# USDA Site Assessment and Geotechnical Engineering Services for the Pender County Health and Human Services Building

### RFQ # 221025-236 ADDENDUM 1

#### Addendum 1 is being issued to provide soil boring locations and soils report requirements.

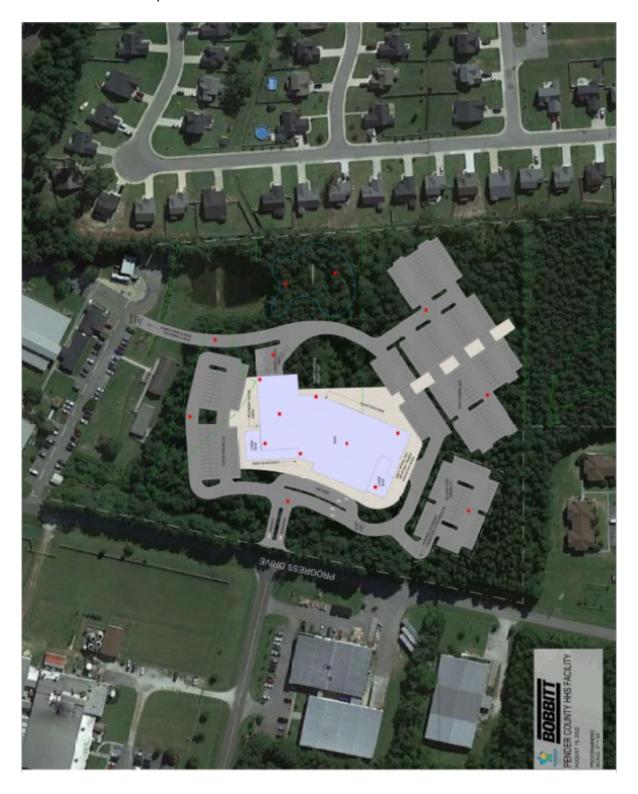
This Addendum provides the requested soil boring locations are denoted by the red dots overlaid on the site map below.

- Minimum of 8 borings under the anticipated building footprint (4 @ 30' depth and 4 @ 60' depth)
- Minimum of 7 borings (x 10' min depth) in parking/drives

- Minimum of 2 borings (x 15' min depth) in the stormwater pond
- Pavement design recommendations based off geotechnical findings
- Determine seasonably high water table in the area next to the existing pond and in the stormwater pond.
